Rezoning Transportation Analysis

Petition Number: 2021-176

Date	Description
11-19-21	First Review (TM)
12-17-21	Second Review (WB)

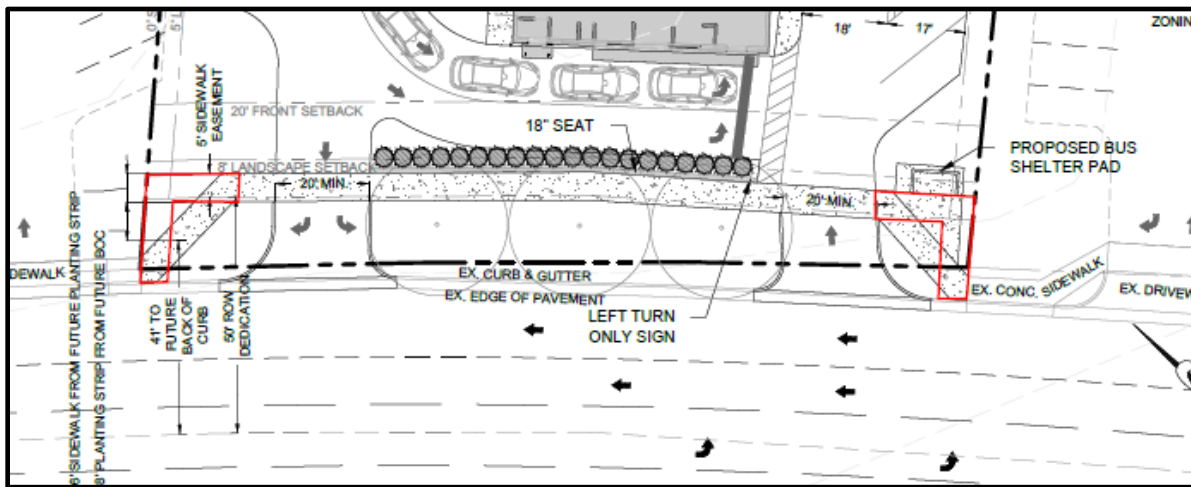
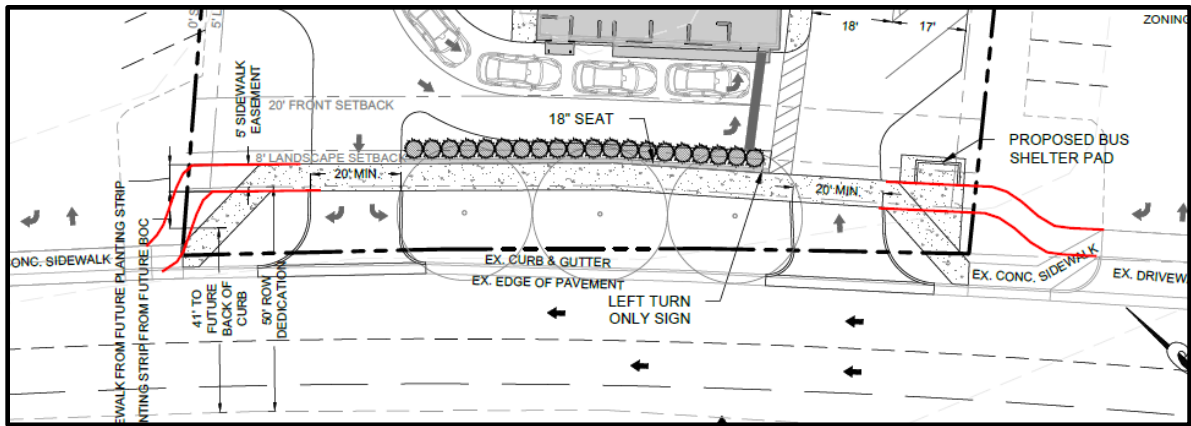
5. COMMENT CLARIFICATION (site plan, 12/15/2021)

Revise site plan and condition note(s) to commit to maintaining a consistent offset from the back of curb to the sidewalk along the site's frontage. Developer to transition to the adjacent sidewalk at the property line using CLDSM 10.23 or at the property line with an interim perpendicular tie in. Refer to markups below.
